**REVIEW OF REVISED SHELTER-IN-PLACE PLAN FOR THE MUSLIM SCHOOL
IN SANTA CLARA, CA**

Ramboll US Consulting, Inc. (Ramboll) has prepared this letter report to summarize our review of the revised Shelter-in-Place (SIP) Plan for the Muslim Community Association's (MCA's) Muslim School and associated religious facilities located at 3003 Scott Boulevard and 3080 Alfred Street in Santa Clara, California (the "Site").

Ramboll understands that the revised SIP Plan for the MCA campus is comprised of seven diagrams (see Appendix B), which are summarized below:

SIP-202.1

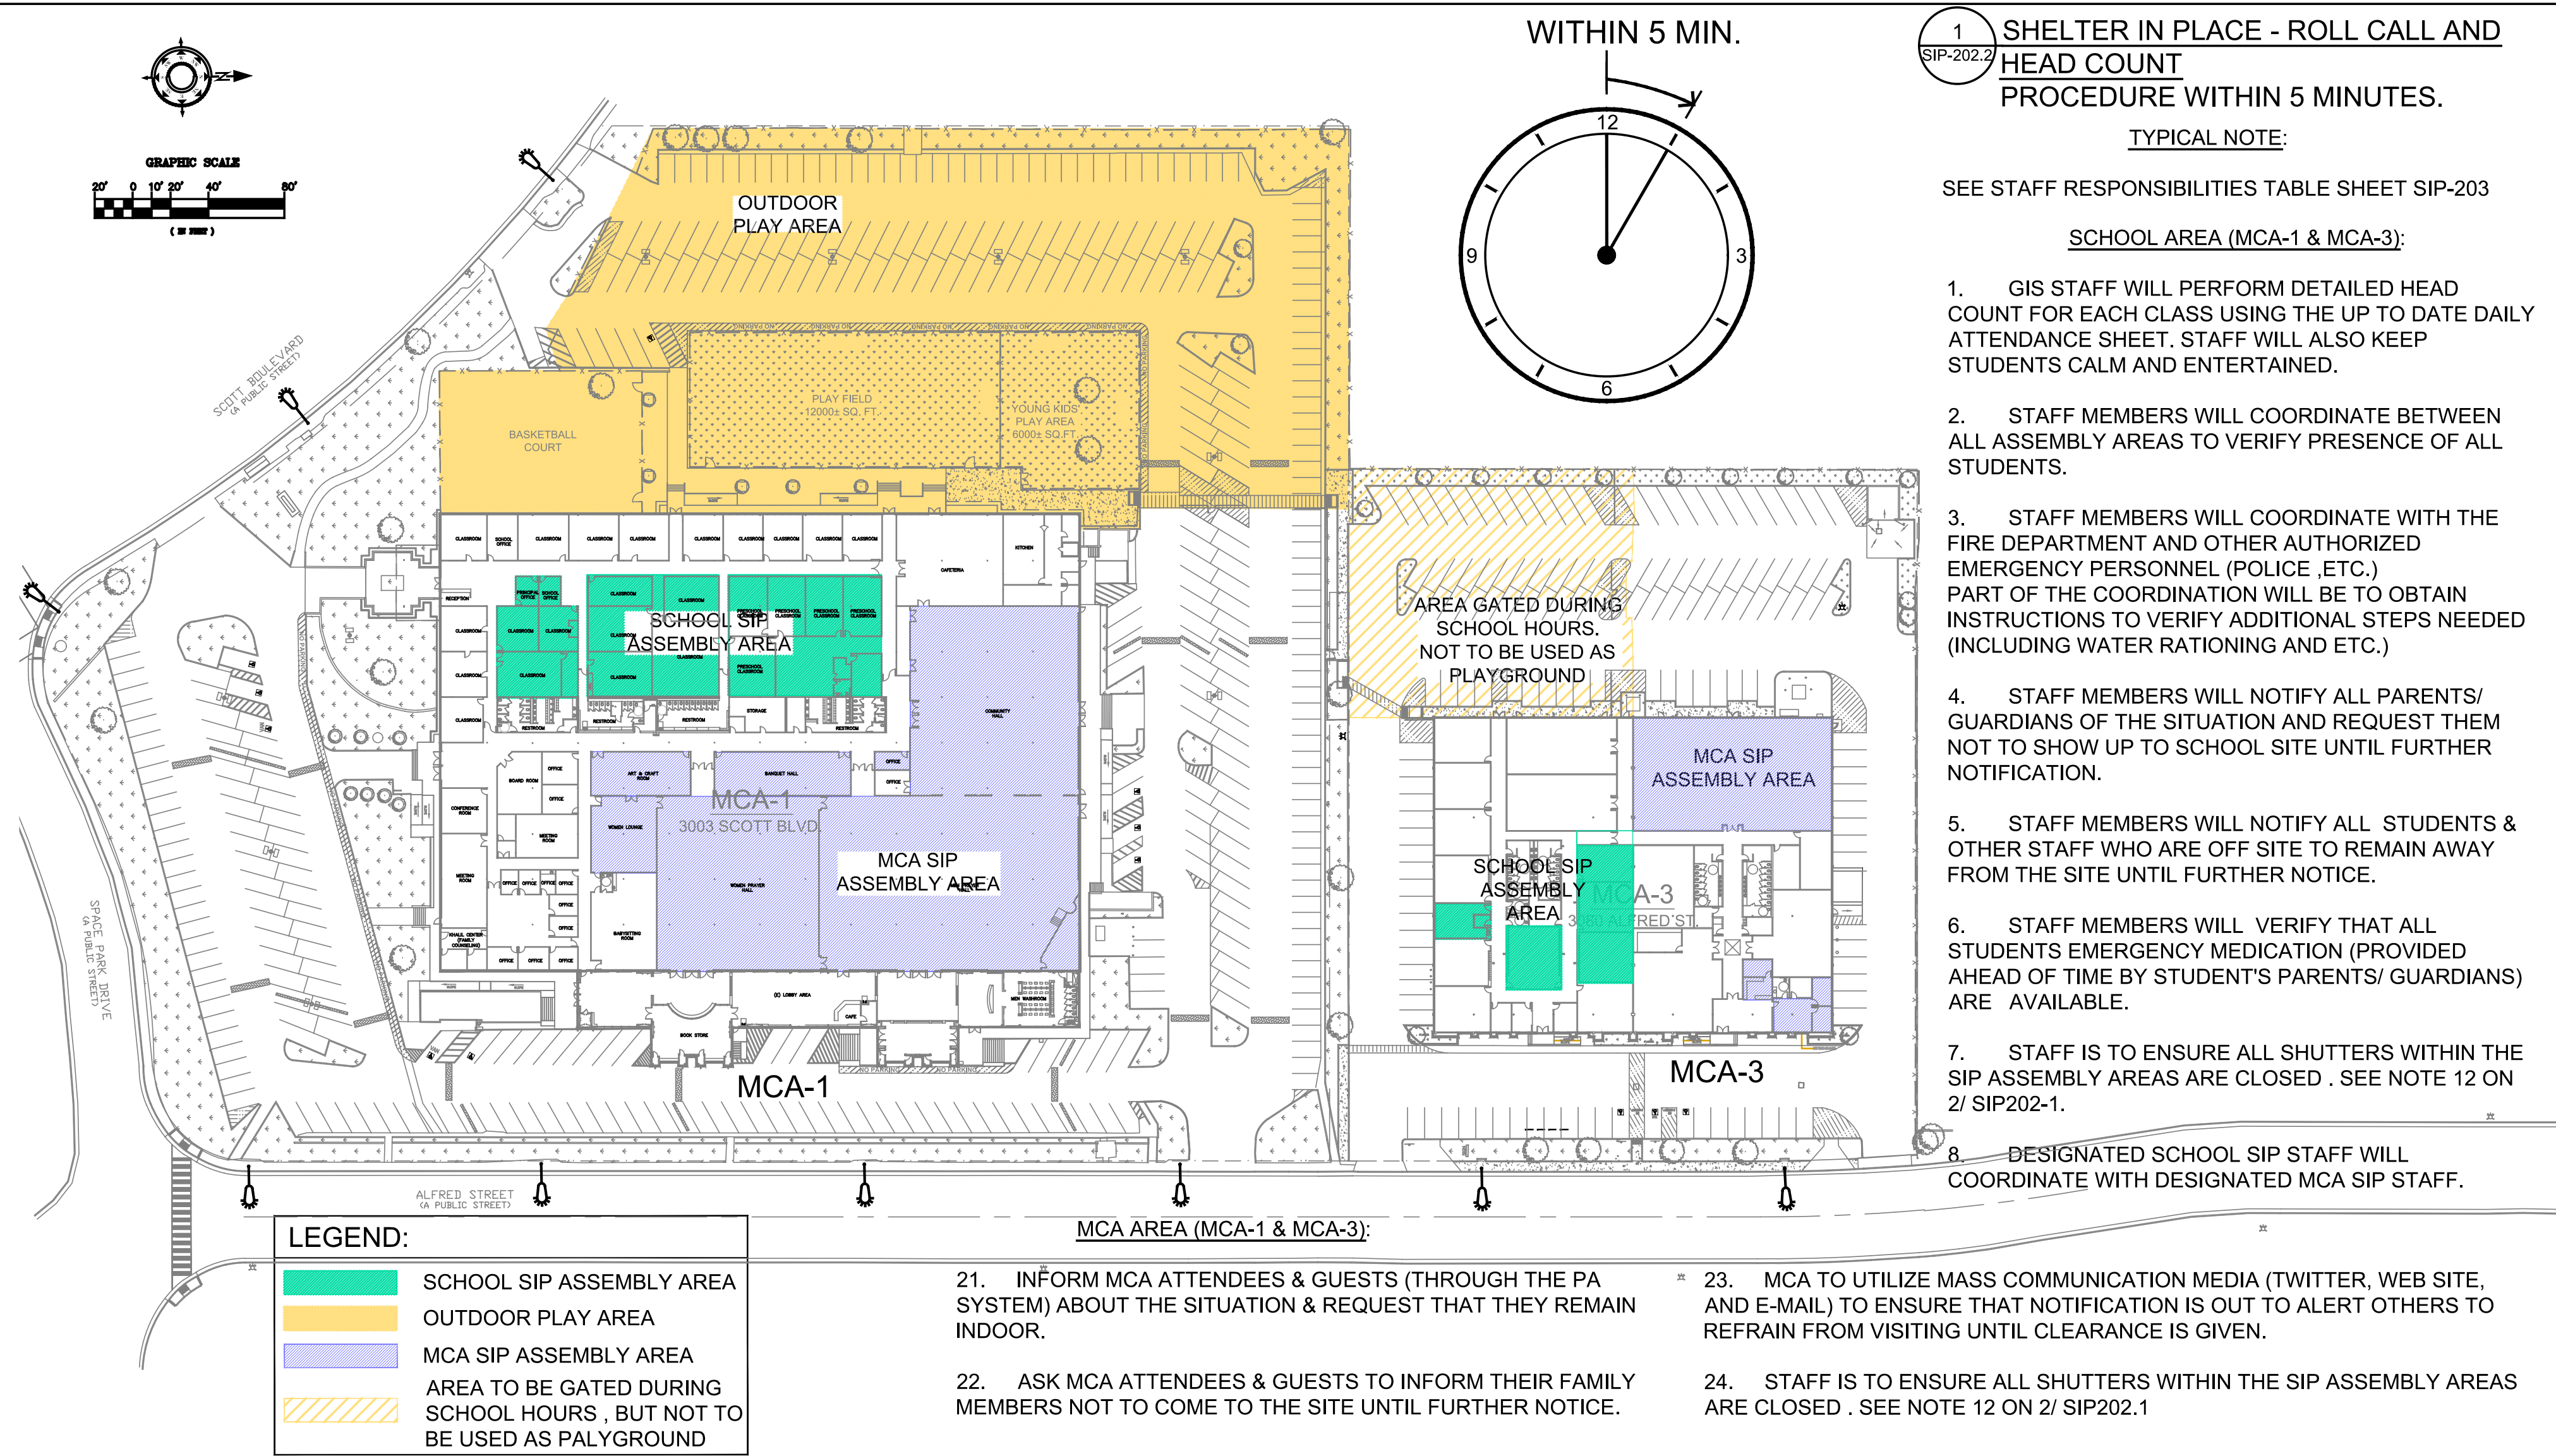
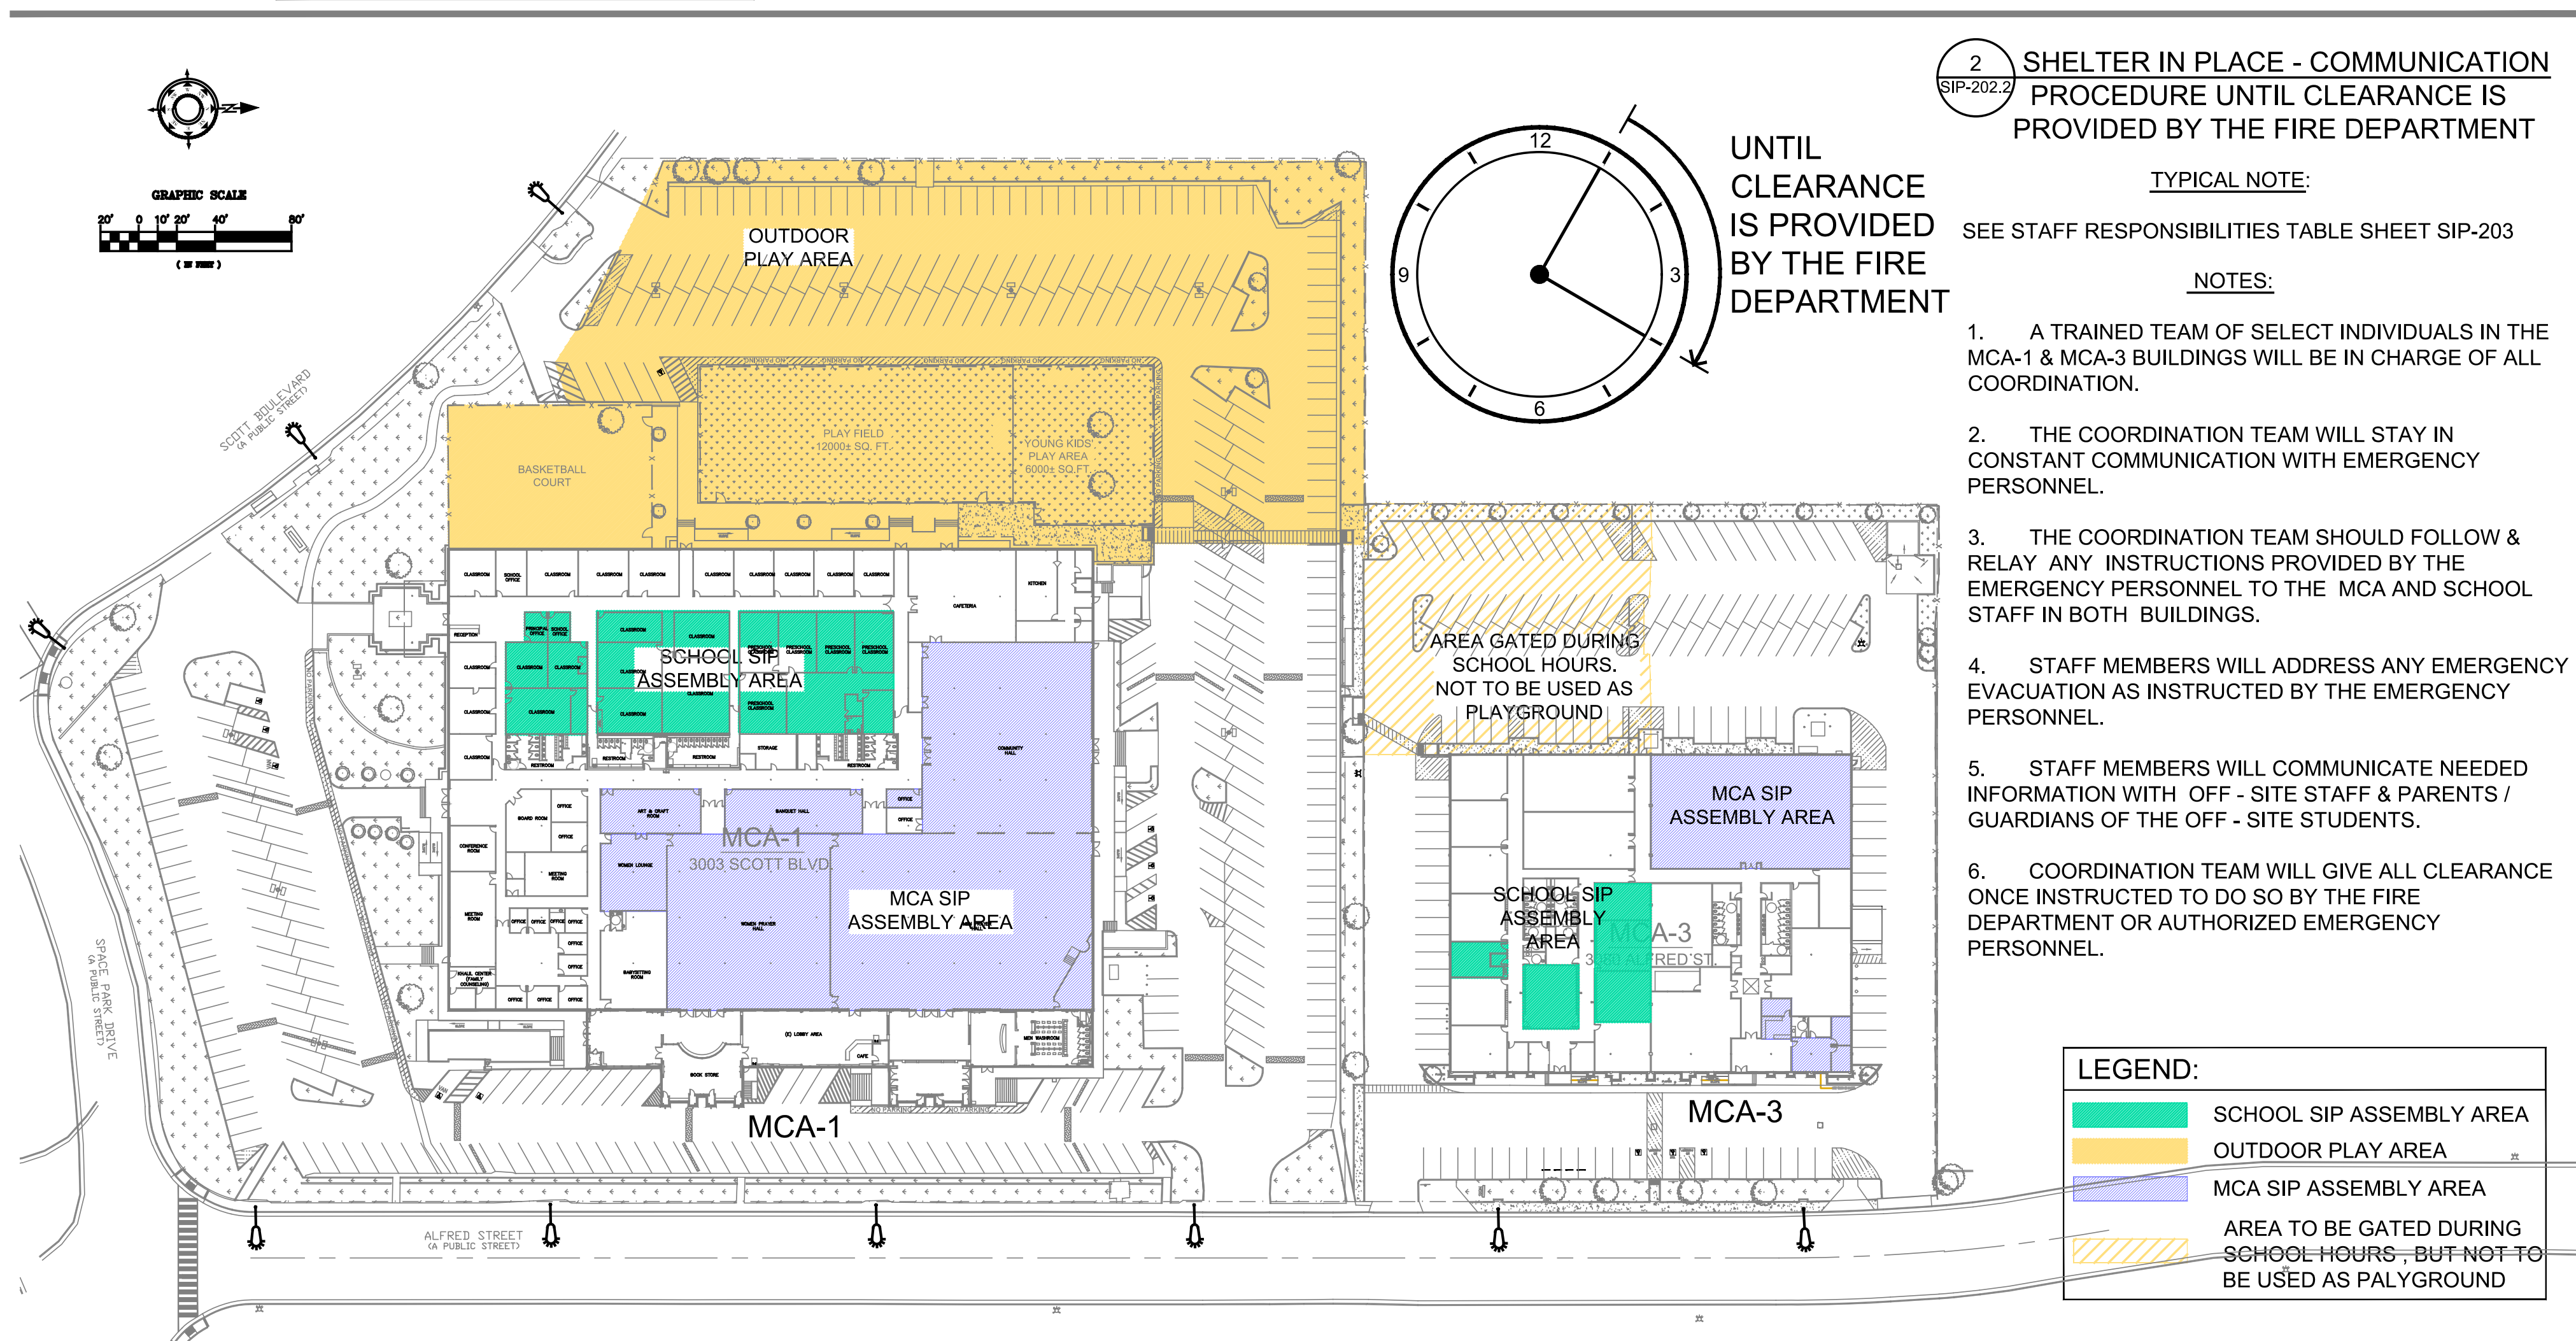
- Ramboll understands that the diagrams illustrating the SIP areas and describing the SIP procedures (i.e., Sheets SIP-201, SIP-202.1 and SIP-202.2) will be posted throughout the MCA campus for reference by MCA staff, students, and visitors. These diagrams are difficult to read due to the small font size. Ramboll recommends enlarging the font on these diagrams by expanding each diagram to fit the full-page area, modifying the sizes of the text areas to more efficiently utilize space, moving the Objectives and Preparation sections (i.e., 1SIP-202.1 and 2SIP-202.1), the Post-Shelter-in-place section (i.e., 3SIP-202.2) to a separate page, and/or converting the individual sections in each diagram to separate figures.

- If it is not possible to identify an alternative location that meets these criteria, Ramboll recommends adding the following additional text to Section 1SIP-202.1: "If it is not possible to locate rooms meeting this criteria, designated shelter-in-place areas shall include classrooms or other areas that have the fewest exterior doors and windows." Ramboll also recommends that MCA develop a procedure to ensure that classrooms and areas with the fewest exterior doors and windows are prioritized as SIP areas, and that these areas be designated by a color-coded sheet of paper designating SIP and non-SIP locations.

- The revised SIP Plan includes several preparation measures that require regular inspection and maintenance of the SIP system and its components (i.e., Procedures 6-8 of Section 2SIP-202.1). Ramboll recommends that these inspection and maintenance activities be documented in a log and stored in an accessible location for inspection by the SCFD, if requested.

- The revised SIP Plan ("Preparation section") specifies that a system for emergency mass communication will be provided to keep parents and guardians informed about SIP situations (See Procedure 3A of 2SIP-202.1). The revised SIP plan ("Shelter In Place – Roll Call and Head Count Procedure within 5 minutes") states that MCA will utilize mass communication media (twitter, web site, and e-mail) to ensure notification is sent to alert others to refrain from visiting until clearance is given (See Procedure 23 of 1SIP-202.2). Ramboll recommends that the revised SIP Plan include specifics about this communication system including the process for registration to the system, and how calls and emails will be answered.
- Ramboll recommends that the mode of communication between the SIP Coordination Team and staff be identified in the SIP Plan (See 2SIP-202.2).

- The SIP procedures outlined in Section 4SIP-202.1 on Sheet SIP-202.1 ("Invacuation Process") and Sections 1SIP-202.2 ("Shelter In Place – Roll Call and Head Count"), 2SIP-202.2 ("Shelter In Place – Communication") and 3SIP-202.2 ("Post Shelter In Place") on Sheet SIP-202.2 do not identify the specific SIP Coordination Team member role with responsibility for each measure (i.e., these measures only identify "staff," with a note referring to Sheet SIP-203). Although this information is provided in the table on Sheet SIP-203, Ramboll recommends that MCA revise the procedures in each section above to indicate the SIP Coordination Team member role(s) with responsibility for each procedure.

adding the following procedure to Section 2SIP-202.1 ("Preparation for Shelter In Place Program") on Sheet SIP-202.1: Cut plastic sheeting in sections large enough to fill gaps around outside and mid-hall doors and exterior windows. Store pre-cut plastic sheeting and tape/adhesive in readily accessible locations near exterior doorways and windows.
